Access Compliance Report

Public Rights-of-Way

(Curb Ramps)

Intersection ID: 14925	Main Street: BROMLEY_RD	Cross Street: QUEENS_RD	Location: SE
ADA ID: 50C58EC54962	Ramp Type: Perp	Initial Pass/Fail: Fail	Overall Compliance: No
		Severity Score: 25

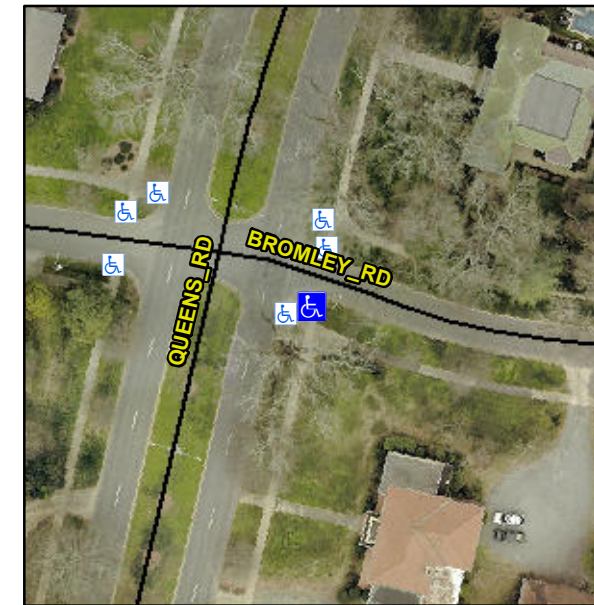
Not Found, R304.2.2, R304.5.3

Compliance	Description	Data	Compliance	Description	Data
N/A	Ramp Length (in)	42.0	No	Ramp Slope (%)	9.5
Yes	Ramp Width (in)	48.0	No	Ramp XSlope (%)	5.4
N/A	Flare Type LT	N/A	N/A	Flare Type RT	N/A
N/A	Flare Slope LT (%)	N/A	N/A	Flare Slope RT (%)	N/A
N/A	Flare Traversable LT?	N/A	N/A	Flare Traversable RT?	N/A
N/A	Landing Length (in)	N/A	N/A	DWS Provided?	N/A
N/A	Landing Width (in)	N/A	N/A	DWS Contrast?	N/A
N/A	Landing Slope (%)	N/A	N/A	DWS Length (in)	N/A
N/A	Landing X Slope (%)	N/A	N/A	DWS Full Width?	N/A
N/A	Landing Curb? (Y/N)	N/A	N/A	DWS Offset (in)	N/A
N/A	Shared Landing?	N/A			
N/A	Gutter Ponding?	N/A	N/A	Gutter Slope (%)	N/A
N/A	Gutter Lip Ht (in)	N/A	N/A	Gutter X Slope (%)	N/A
N/A	Painted X Walk1?	No	N/A	Painted X Walk2?	N/A
	X Walk 1 Direction	To NE		X Walk 2 Direction	N/A
N/A	X Walk 1 Width (in)	N/A	N/A	X Walk 2 Width (in)	N/A
	X Walk 1 Slope (%)	5.3		X Walk 2 Slope (%)	N/A
	X Walk 1 X Slope (%)	2.9		X Walk 2 X Slope (%)	N/A

Remove & Replace Entire Ramp.
